Tennessee Valley Authority, 1101 Market Street, Chattanooga, Tennessee 37402

CNL-19-106

Watts Bar Nuclear Plant, Unit 2
Facility Operating License No. NPF-96
NRC Docket No. 50-391

Subject: **Supplement to Application to Modify Watts Bar Nuclear Plant Unit 2 Technical Specifications 3.7.8 to Extend the Completion Time for an Inoperable Essential Raw Cooling Water Train on a One-Time Basis (WBN-TS-18-07) (EPID L-2019-LLA-0020)**

Figure 1 - WBN ERCW Intake Temperature History

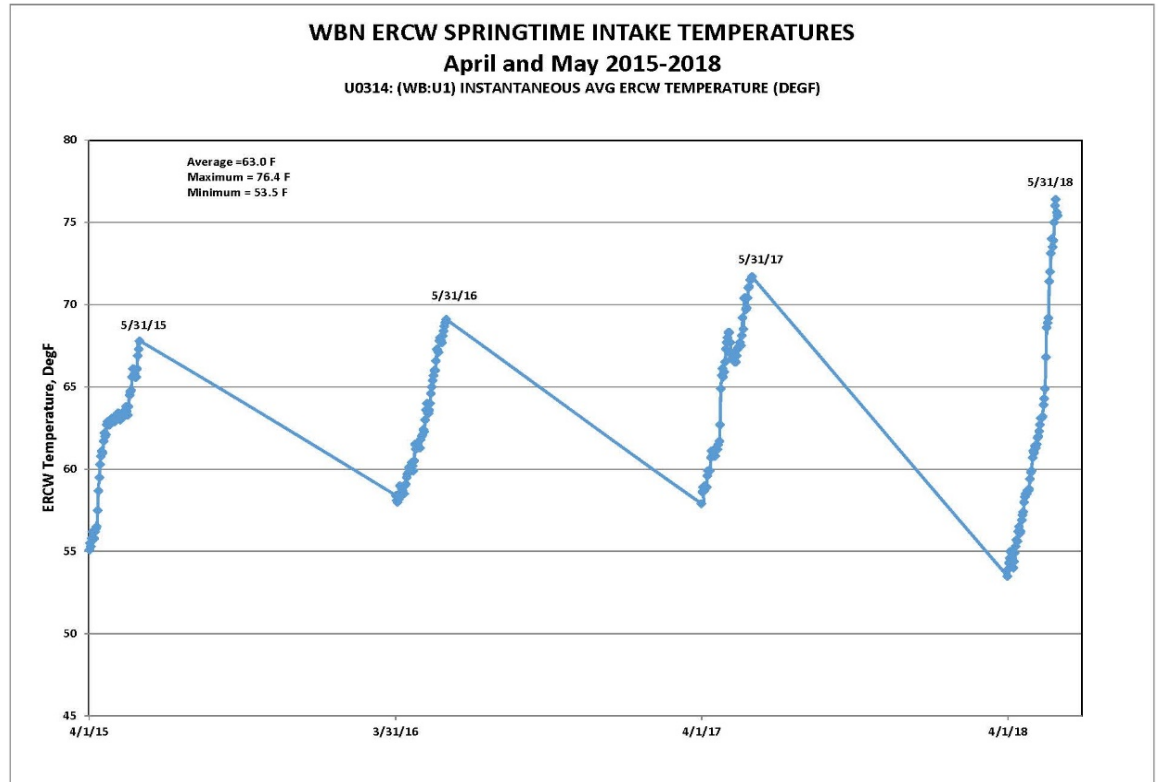
The enclosure to this submittal provides a revised Section 2.2 of Enclosure 1 to the referenced letter reflecting the above date change. The enclosure also provides a revised Figure 1 from Section 3.2.4 of Enclosure 1 to the referenced letter to reflect the WBN ERCW intake temperature history from April and May between 2015 and 2018 along with the corresponding text for this figure. Revision bars are provided in Enclosure 1 to reflect the changes. The revised Sections 2.2 and 3.2.4 of Enclosure 1 to the referenced letter supersedes the one provided in the referenced letter.

As indicated in Figure 1, a review was performed of the past four years of plant data for the ERCW temperature throughout the months of April and May. As shown in this figure, the overall average temperature is 63°F. While Figure 1 does show ERCW temperatures exceeding 71°F towards the middle to later periods of May, it should be noted that the planned maintenance of the 6.9 kV SDBD 1A-A and associated 480 V boards and MCCs is planned to be completed within the first two weeks of the U1R16 outage following WBN Unit 1 being defueled (i.e., the planned maintenance is planned to be completed by May 7, 2019). Therefore, the ERCW temperature is expected to be below 71°F when the planned maintenance is performed. Additionally, during the outage, TVA monitors the river temperature to ensure the ERCW temperature is not expected to exceed 71°F during the period of the scheduled maintenance. Furthermore, the results of the thermal-hydraulic analysis provided in Section 3.2 remain valid for determining that ERCW will supply adequate cooling to WBN Unit 2 during a postulated loss of coolant accident (LOCA), as well as WBN Unit 1 after entering a defueled condition, when the UHS temperature is less than or equal to 71°F. The date of May 31, 2020, in Note 1 to the proposed TS 3.7.8 Condition A is approximately one week from the scheduled end date of the U1R16 outage to allow for sufficient time for any unexpected delays during the U1R16 schedule. In the unlikely event the UHS temperature exceeds 71°F during the performance of the planned maintenance, TVA would take the appropriate actions in accordance with TS 3.7.8.
